DESIGN REVIEW : APARTMENTS 14TH AVE.W

DESIGN GUIDANCE RESPONSES

## RECOMMENDATION MEETING : Apartments 2556 14th Ave. W

LANDSCAPE PLAN AT GROUND LEVEL

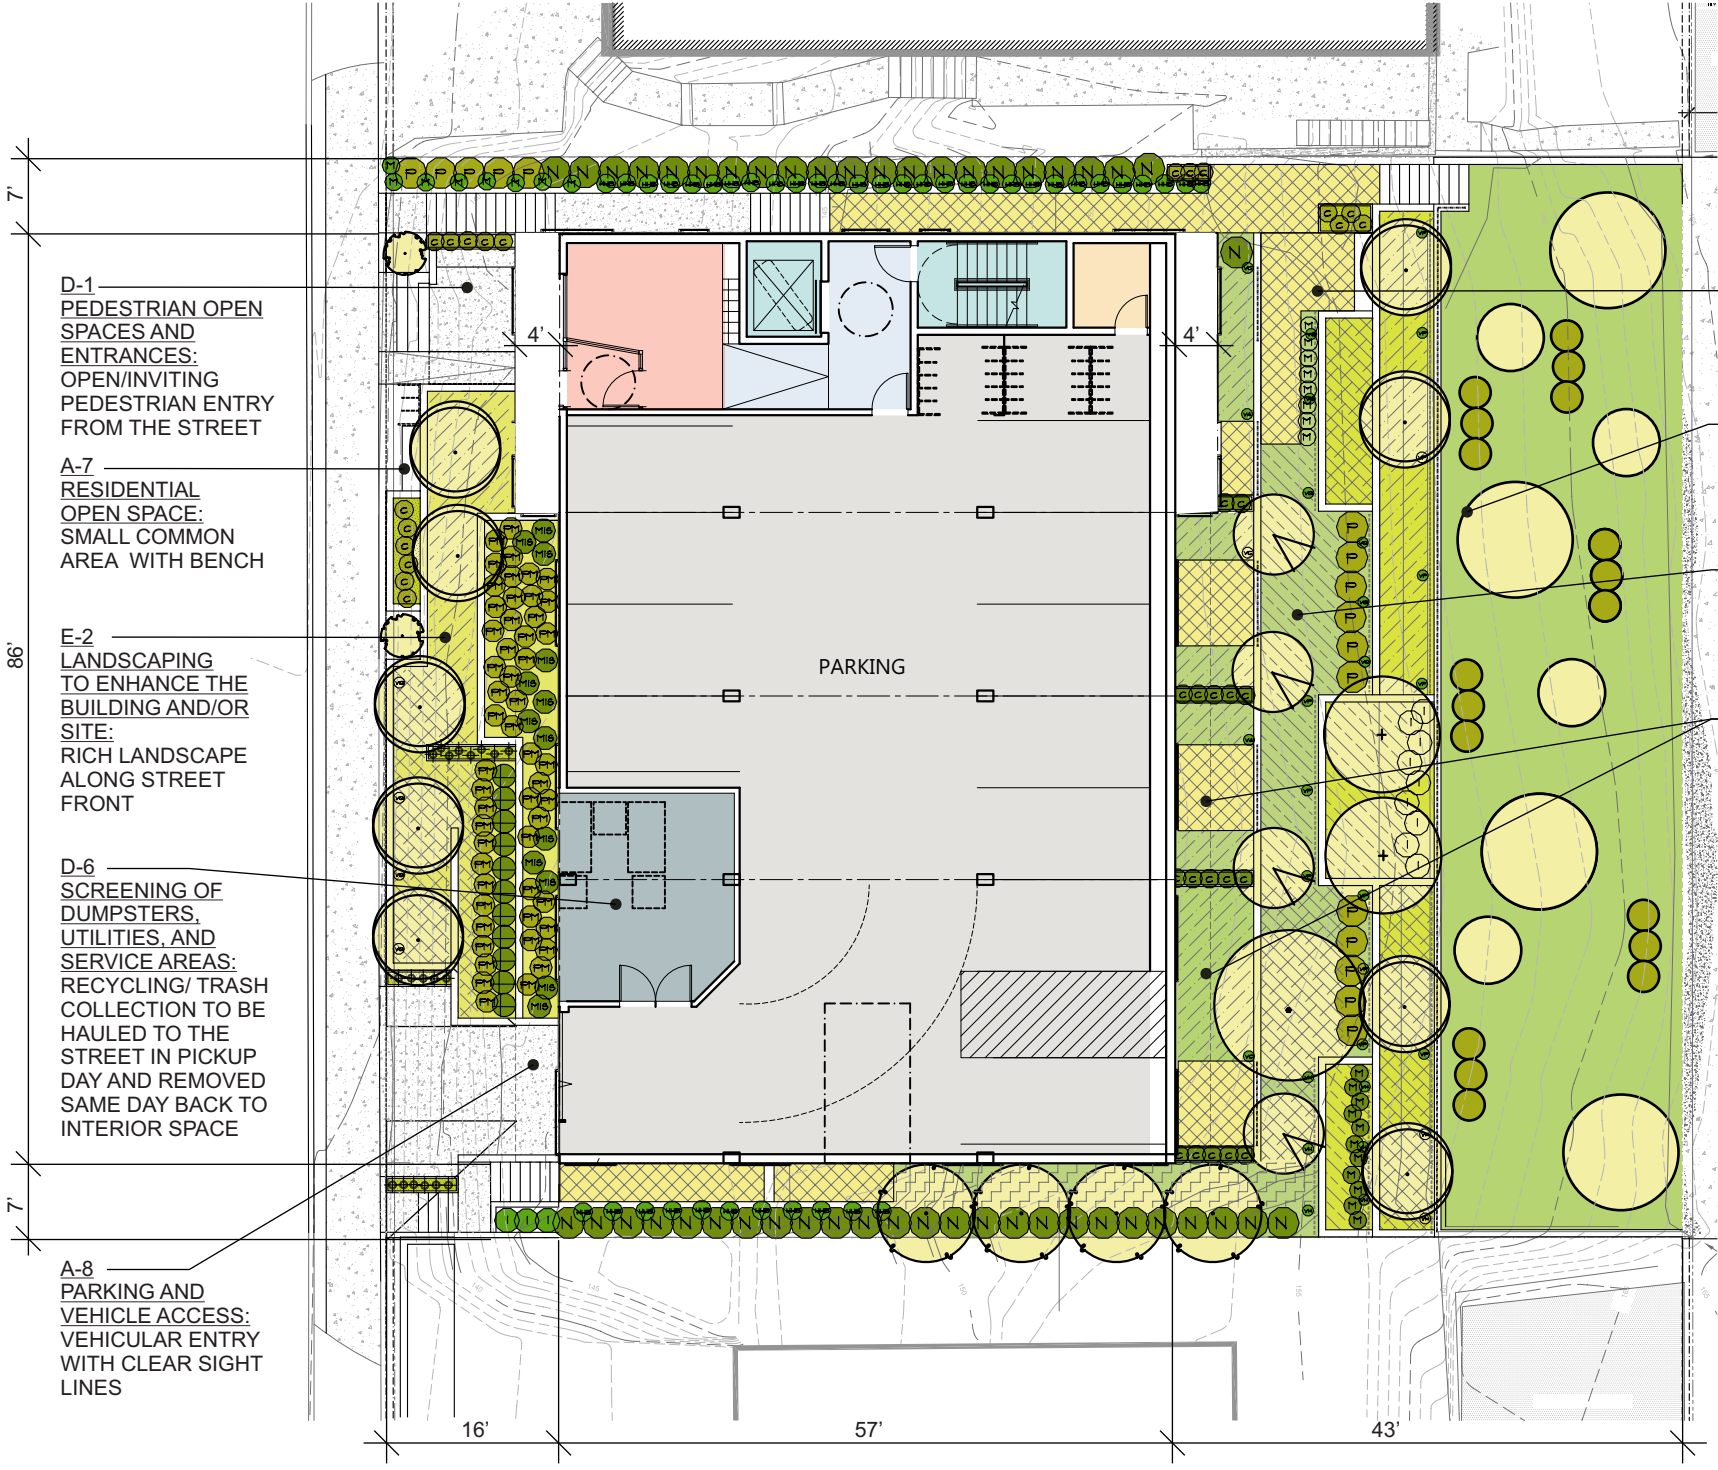
At the Early Design Guidance Meeting, the Board discussed the need for sufficient programmed residential open space on the site. The open space should be designed to provide usable gathering areas for residents.

At the Early Design Guidance Meeting, the Board discussed the applicant's Intent to design for sustainability (Built Green four-star). The applicant should indicate how sustainability goals relate to the proposed design and the slope, with particular attention to storm water detention/retention, vegetation, and green walls. The slope Introduces challenges for the site, Including views from nearby properties, provision of usable outdoor open space at grade and on the roof. and pedestrian access across the site. The applicant should demonstrate how the proposed design responds to these challenges. The Board noted that the high bank condition at 14th Ave W should Include a variety of plant materials.

**Private open space is provided at ground level on the east side of the project, with rich landscaping and green walls providing privacy. Common open space, suitable for gatherings, is provided on the rooftop deck which is surrounded by landscaping and vegetated green roof. (see Landscape plans). The pedestrian entry area at ground level can accommodate a small group to gather.**

**The 14th avenue high sloped bank is heavily landscaped with a large variety of shrubs, trees and ground cover. Retaining walls on the east side of the building will feature green walls as well as intense vegetation. Together, these elements will facilitate storm water retention and provide privacy. The green roof and the permeable pavers on the outdoor parking area help to mitigate storm water outflow, lower heat gain, and make the project more attractive when viewed from nearby properties. Pedestrian access across the steep site is provided by paved paths and staircases with a very direct connection from the alley parking to the 2<sup>nd</sup> floor elevator lobby.**

LANDSCAPE PLAN AT ROOF

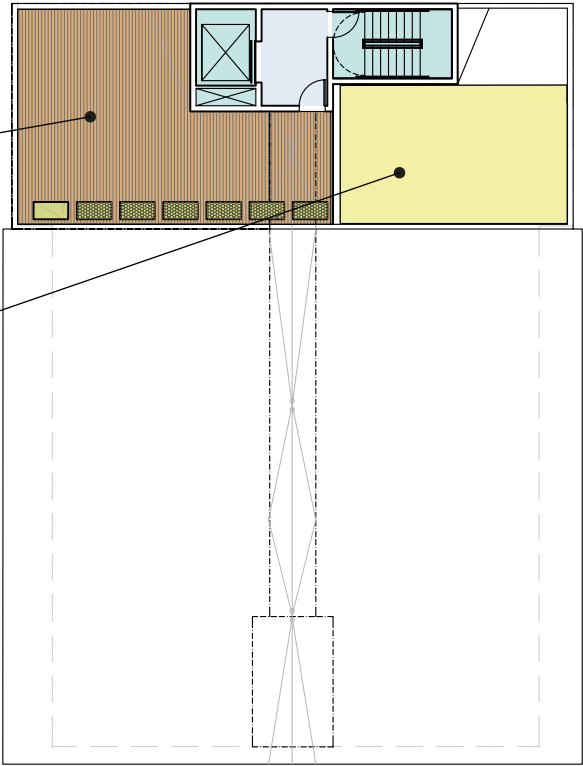
At the Early Design Guidance Meeting, the Board noted that In addition to comments for Guideline A-7, the applicant should include a green roof, given the visibility of the roof from properties uphill of the site. The pedestrian entry should be clearly Identifiable from the garage entry and be designed as a building amenity. Possible enhancements Include a bench, distinct canopy, landscaping, special paving, and interesting materials.

**There is a green roof proposed. The pedestrian entry to the project was made more open and inviting and active, allowing for visual control and site security. Proposed elements include: a distinct metal canopy, built-in benches, bicycle parking area, and multiple landscape planters.**

## ADJACENT BUILDINGS : WINDOW OFF-SET

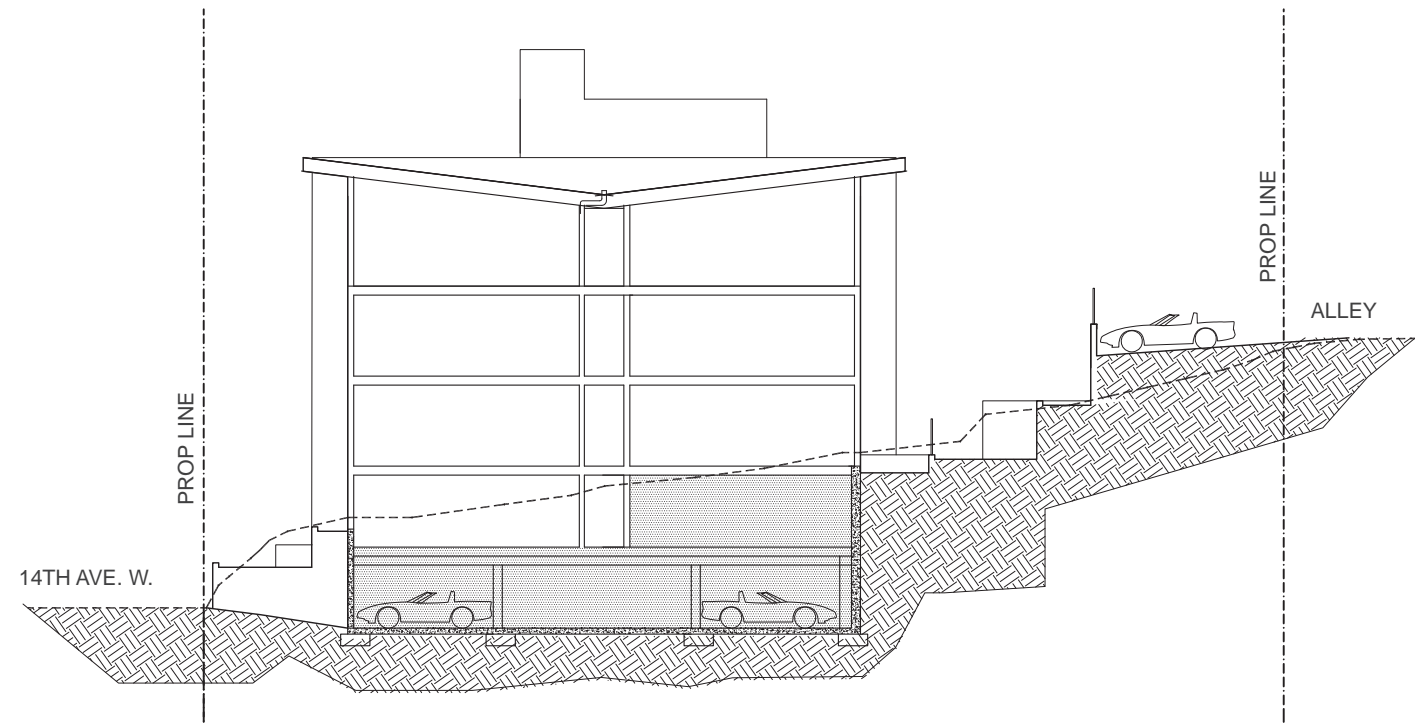
At the Early Design Guidance Meeting, the Board directed the applicant to design In response to street wall context described In A-1, and also design the north and south facades of the building to sensitively address privacy Impacts to the adjacent neighbors. The Board noted that the larger windows on the east and west facades and smaller windows on the north and south facades are a positive step In the right direction.

**Refer to response in A-1. Proposed project is limiting windows facing adjacent properties to the north and south, and we provide additional landscaping in side setbacks to provide additional screening. Frosted glass is used in the few instances where windows are directly across from each other (see illustration).**

VIEW OF STREET FRONT AT 14TH AVE. W.

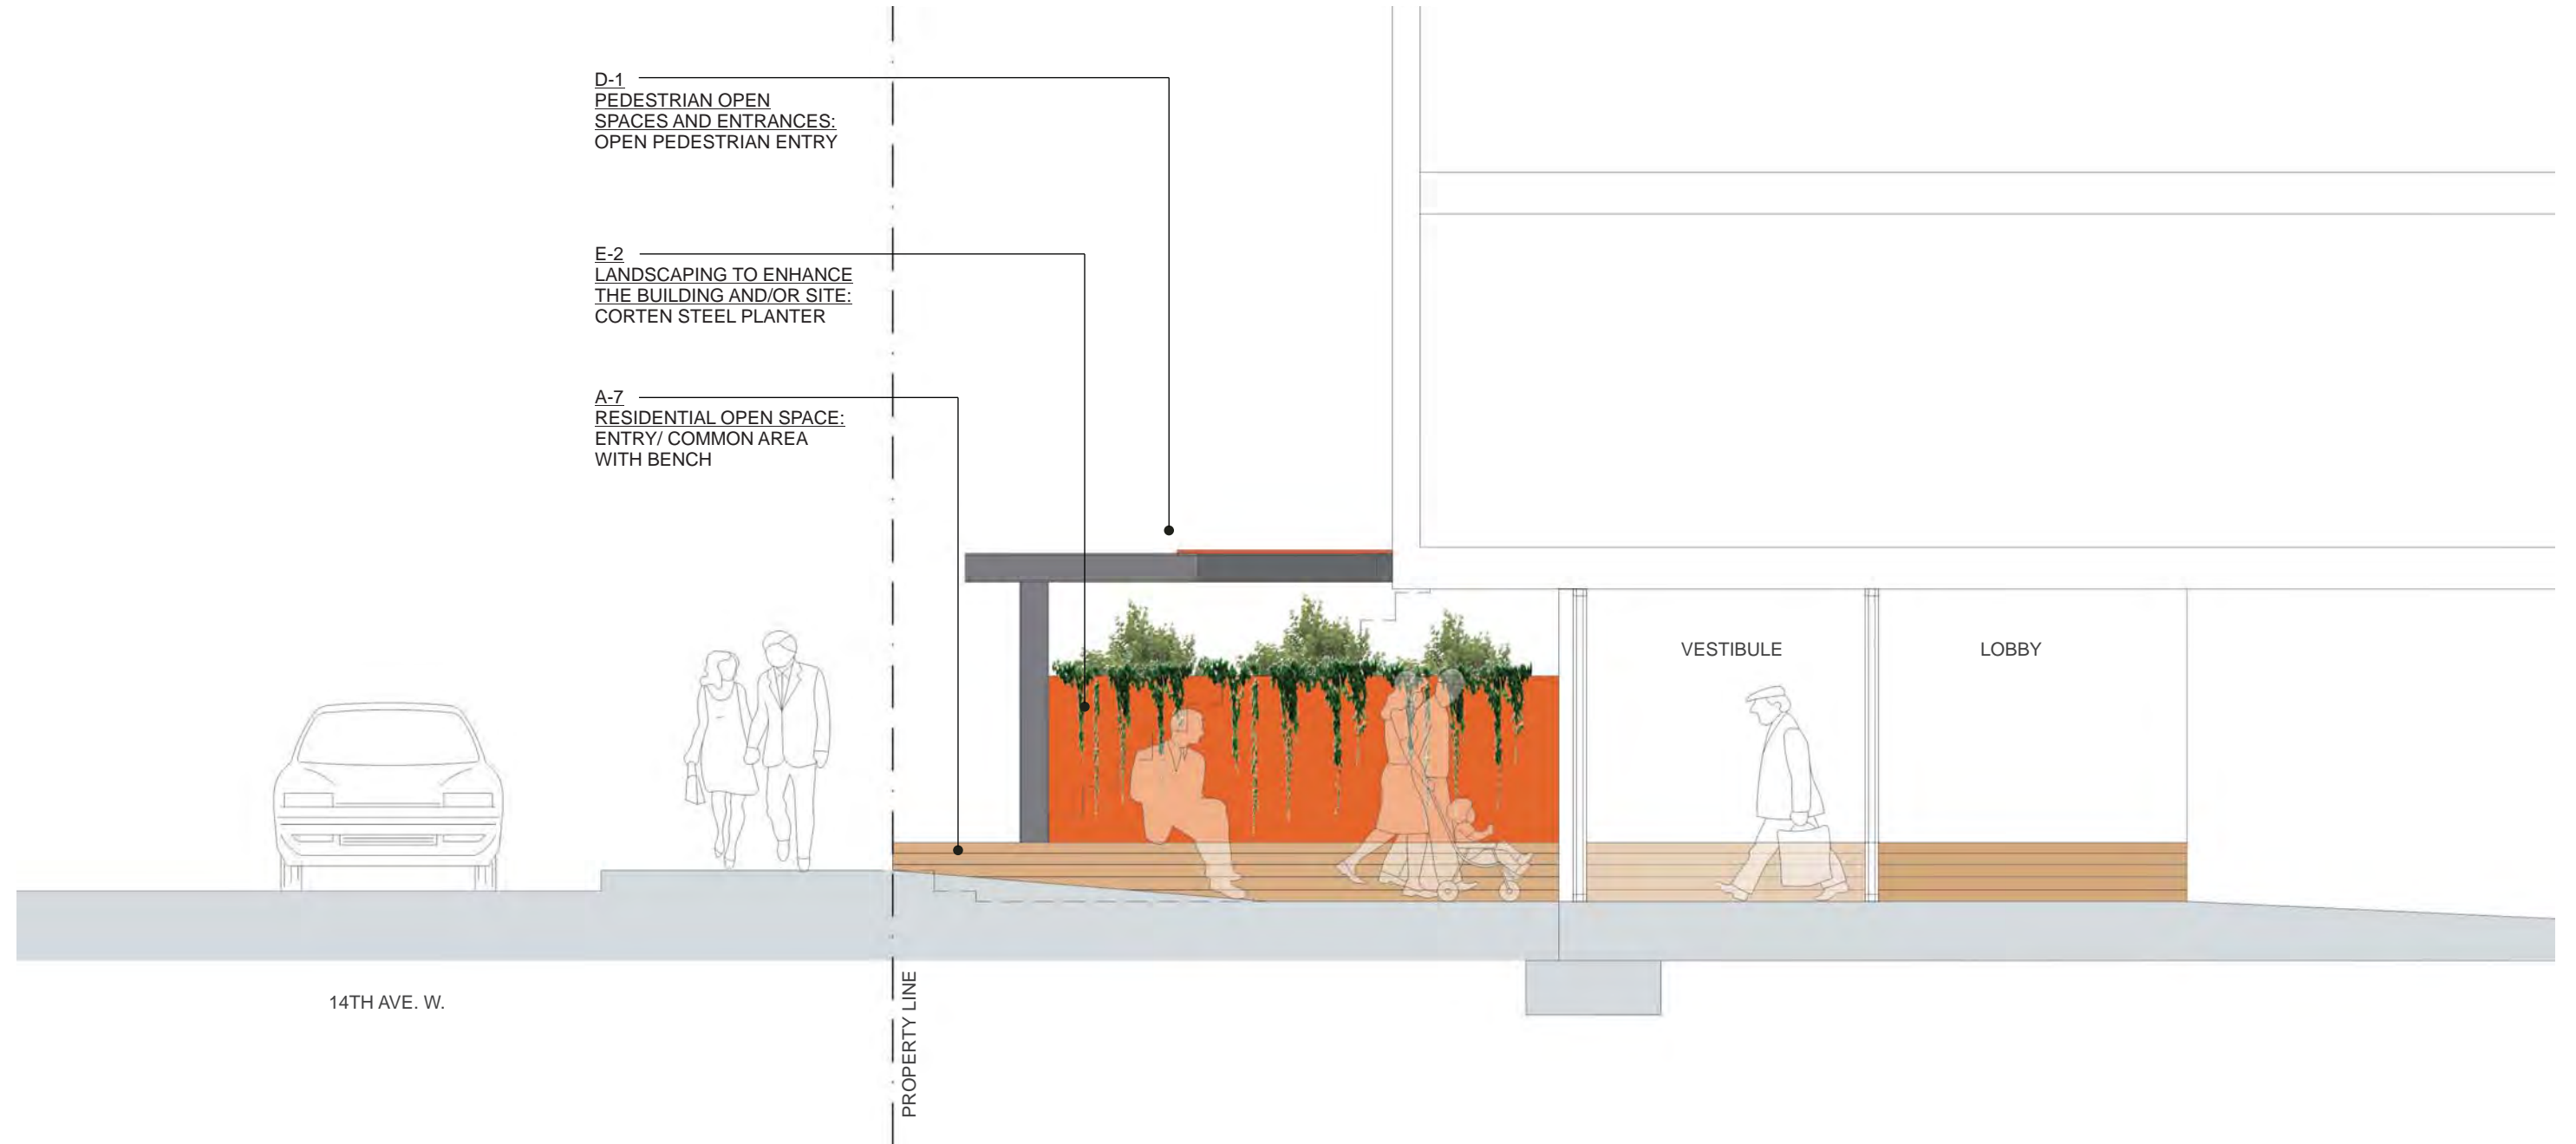
At the Early Design Guidance Meeting, the Board noted that In addition to the comments for Guideline A-1, the applicant should design to provide adequate sight triangles at the 14th Ave W driveway. The sidewalk is narrow, and the retaining walls and high bank condition make clear sight triangles a necessity at this site.

A-8 Parking, and Vehicle Access. Siting should minimize the Impact of automobile parking, and driveways on The pedestrian environment, adjacent properties, and pedestrian safety. At the Early Design Guidance Meeting, the Board noted that in addition to the sight triangles discussed In response to Guideline A-2, the driveway should be designed with pedestrian safety as a focus, and landscaping and other design efforts to reduce the visual appearance of the garage entry.

At the Early Design Guidance Meeting, the Board directed the applicant to design the garage entry door in a high quality Interesting material that is architecturally compatible with the overall building design. The garage entry door will be a highly visible component of the streetscape facade, making careful design of this element especially important.

**We have modified and staggered retaining walls and grades to provide clear visual awareness of vehicular access for pedestrians. Full legal site triangles are provided.**

**The Parking garage entry is surrounded by landscaped areas and Corten steel planters which soften and cover the retaining walls.**

**We propose a custom designed garage door. The door has multiple vertical and horizontal bars which frame around perforated metal panels (for required ventilation). See sample image attached.**
